Sandon Point Modification 5

Modification to Seniors Living and Residential Development
Concept Approval Modification Assessment
(MP06_0094 MOD 5)

May 2020

Published by the NSW Department of Planning, Industry and Environment

Figure 17 | Proposed Precinct 1 Layout (source: Proponent's Supplementary Information)

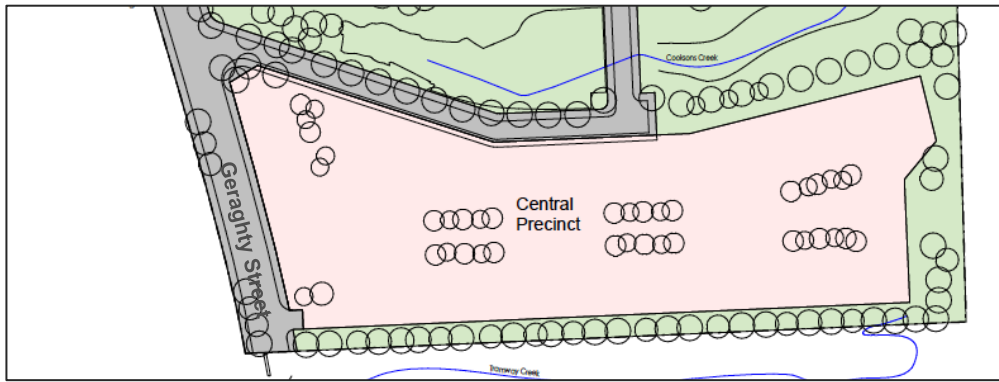
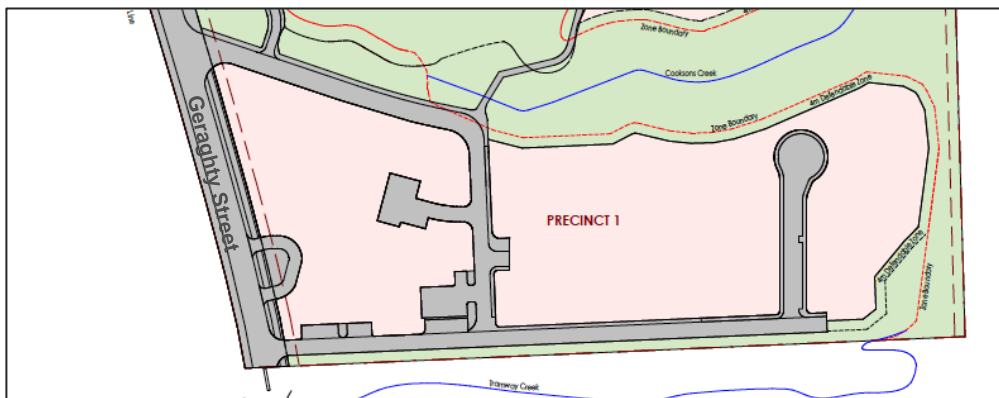
Council raised concerns that indicative architectural plans submitted with the modification showed buildings presenting as four storeys in height (three residential levels above a parking level located partly above ground), which could result in adverse visual impacts. The Proponent subsequently confirmed that approval is not sought for the indicative plans and the buildings would be subject to future DAs. As with the existing approval, all future development would be assessed in accordance with the relevant design requirements of the Seniors Living SEPP.

The current concept approval retains a row of trees along the southern boundary of the site, which would visually screen the development when viewed from the south. The originally proposed modification included a roadway adjacent to the boundary, which results in the removal of those trees. In response to concerns raised by the Department, the Proponent relocated the road slightly north (as seen **Figure 17**).

However, as the size of the setback is not the same as the original approval, the Department recommends a condition requiring future development applications to demonstrate that the alignment of the road and its setback from the boundary will retain existing trees and provide adequate landscape planting to screening along the southern boundary.

Figure 19 | Proposed layout of Precincts 2 and 3 (source: Proponent's Supplementary Information)

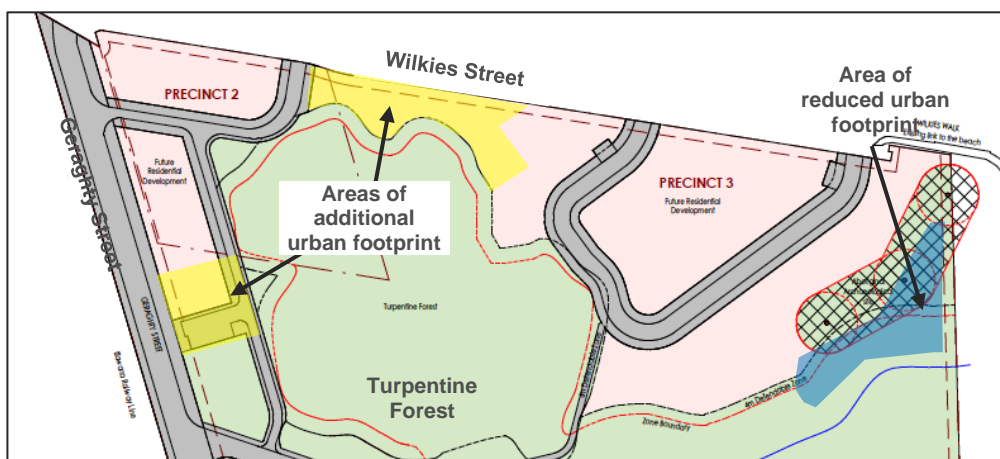
A key concern raised in public submissions was that the proposed 'townhouse' style development was inconsistent with the character of the area to the north of the site, in terms of building heights, style, small lot sizes and dominance of garages and driveway crossovers onto the adjoining streets.

Council raised concerns in relation to the potential future lot layout and future built forms, based on the indicative plans submitted with the application. Specifically issues raised by Council related to proposed building heights (particularly 'basement' level parking being provided above ground and creating a third storey), the appropriateness of two-level dwellings for seniors housing, garage widths exceeding the DCP controls, provision of dual frontage lots resulting in adverse streetscape outcomes, some lots with insufficient depth contrary to the DCP with potential adverse heritage impacts, and potential issues with solar access to private open space.

The Proponent's RtS addressed several of these concerns by providing rear lane vehicular access to most of the dwellings in Precinct 2 and redesigning the road layout to remove dual frontage allotments from the remainder of the site. It also confirmed that approval is not sought for the indicative plans and future subdivision layout, and buildings would be subject to future DAs, but provided a revised indicative layout plan for information purposes (see **Figure 20**).

Figure 21 | Wilkies Street traffic movements (base image source: RTS documents)

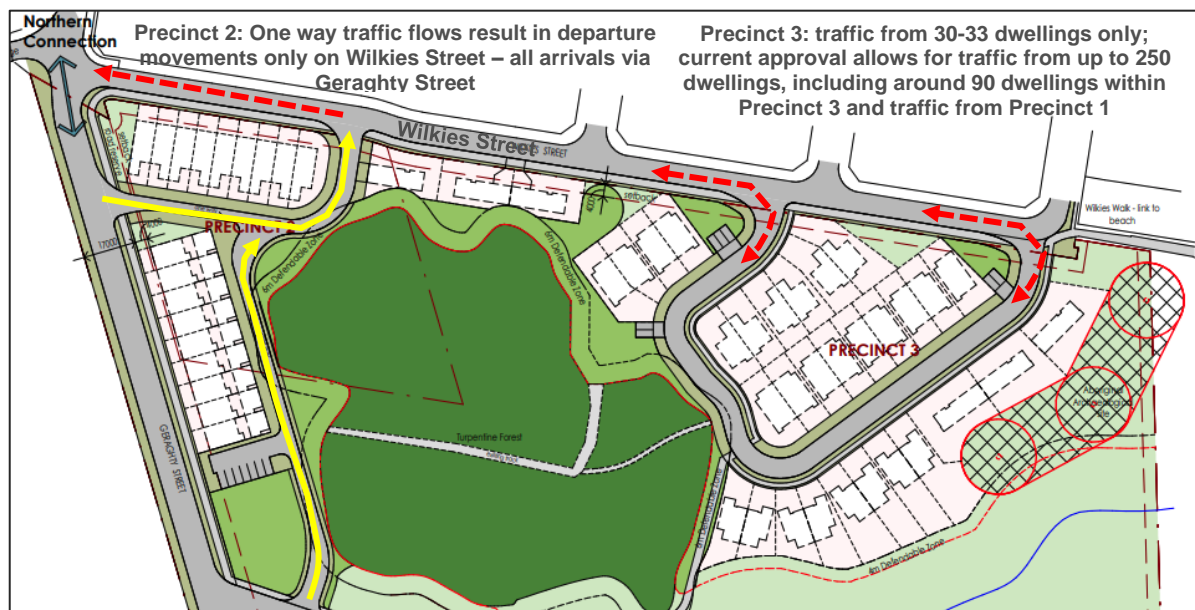
A key concern raised by residents is that Wilkies Street along the northern boundary of the site is very narrow and was not designed to accommodate any additional traffic from the proposed 51 dwellings. Submissions suggest Wilkies Street be widened or an alternative road layout be provided to reduce or remove access to Wilkies Street

The proposed modification reduces density in Precinct 3 from around 90 ILUs to approximately 30 detached and semi-detached dwellings that would use Wilkies Street for access. While a further 18 dwellings in Precinct 2 would also use Wilkies Street (following deletion of three townhouses as recommended in **Section 6.1**), traffic impacts would be shared with Geraghty Street as the one way traffic flow arrangement means only half the traffic (exiting the site) would only use a short section of Wilkies Street (see **Figure 21**).

Further, the through site road from Wilkies Street to Precinct 1 is being deleted under the modification, significantly reducing the overall number of dwellings that have the potential to access Wilkies Street directly from the site.

For these reasons the Department is satisfied that overall traffic movements on Wilkies Street is likely to be reduced or similar to that of the existing concept approval, and as such there is no justification for road widening or alternative road design arrangements.

Figure 22 | Road realignment requested by neighbour
(base image source: neighbours letter of objection)

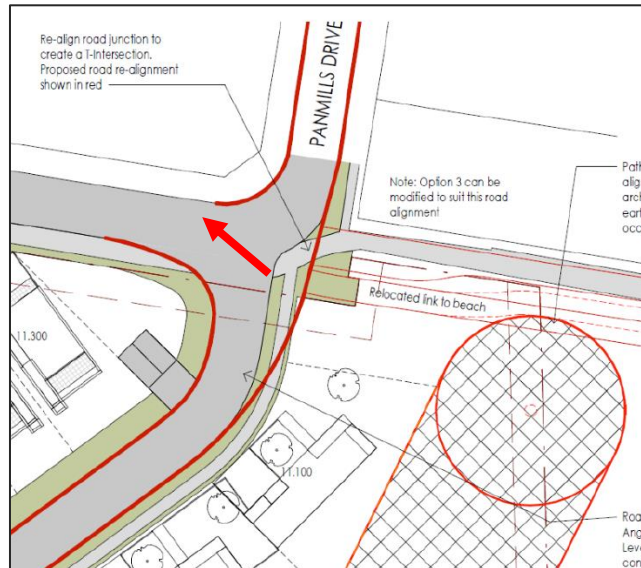
The owner of Lot 101 DP268549 raised concern that the proposed plans do not include a minor amendment to road alignments at the north-east corner of the site previously agreed between the two owners (**Figure 22**). This realignment, as well as the re-location of Wilkies Walk on to the site may be necessary to facilitate vehicular access to Lot 101 over the adjacent road reserve.

It is recommended that the proposed road alignment be flexible to be determined in future development applications. This flexibility will enable any changes to road realignments necessary to provide access to the adjoining development.
